Product Change Notification / SYST-15WGPU924

Silicon Die Revision

ERRATA - PIC18F25/45/55Q43 Silicon Errata and Data Sheet Clarifications

SYST-15WGPU924

1.7.1 UART TXDE Signal May Go Low Before the STOP Bit Has Been Entirely Transmitted

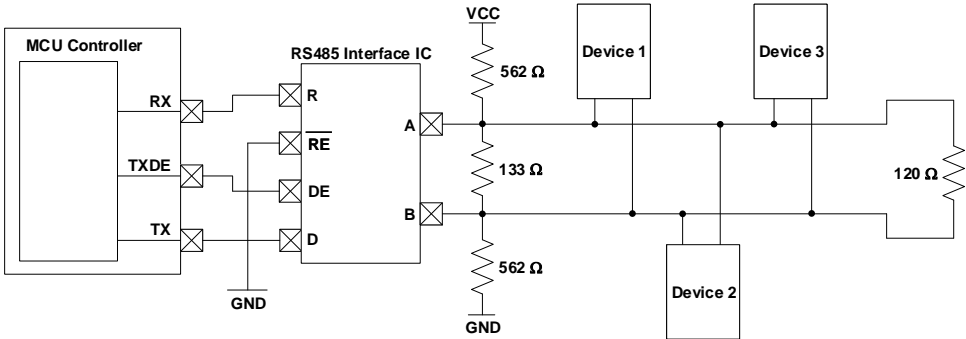
The UART Transmit Drive Enable (TXDE) signal could potentially transition into a low state before the UART STOP bit has been entirely transmitted due to the effects of parasitic capacitance on the TX line. In some applications, this could result in communication being prematurely terminated due to the TXDE bit going low before the STOP bit has had enough time to settle.

To ensure that the STOP bit settles into its final logic state before the TXDE signal transitions low, a biasing circuit can be implemented. A biasing circuit allows the TX line to either be driven high or low, rather than being left in a floating tri-state mode where prolonged rise or fall times could lead to communication being disrupted. This bias circuit should only be implemented on one end of the serial bus, and a termination resistor should be used on the other end. The figure below shows an example of a bias circuit that can be used to achieve this.

Please note that the resistor values used in this circuit are recommendations, and that the actual resistor values required may vary based on the application.
